FLIR Radiation, Inc.
100 Midland Road
Oak Ridge, TN 37830
Tel.: (865) 220 8700 ext.101
Fax: (865) 220 7181

License Number 41-25639-01E

Dated: August 31st, 2011

Reference our license number 41-25639-01E for incorporating an exempt source into the radHUNTER product for internal calibration purposes in accordance with § 32.14 and § 30.15 (a) (9):

Source Mechanical Detail

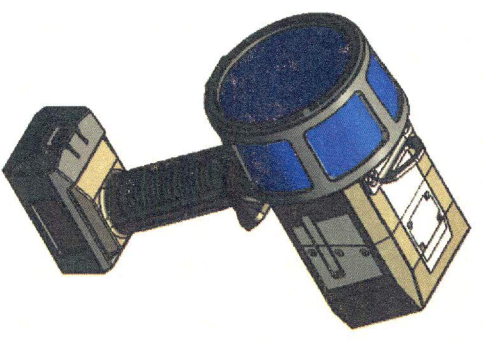
We are also requesting that the Manganese-54 or Cesium-137 sealed source be positioned on the side of the detector PMT versus the end of the detector. Due to the geometry of the detector, the measured peak energy depends greatly upon the position of the source. Changing the position of the source will greatly enhance instrument performance.

The sealed Cesium-137 or Manganese-54 exempt source would be attached to the upper side of the detector PMT by double sided TESA 64621 adhesive tape. In addition to the double sided adhesive tape, approximately 1 ½ x 3" inches, 23-FEP clear adhesive tape would be placed over the Cesium-137 source to provide additional protection against accidental submersion of the products in water. The tape has a strong adhesive that can withstand environmental conditions beyond the products operating range. The housing is constructed from aluminum to prevent any damage to the internal components including the Cesium-137 or Manganese-54 source. Work instruction "wi-5010-radhunter-source-assembly" provides instructions on source assembly.
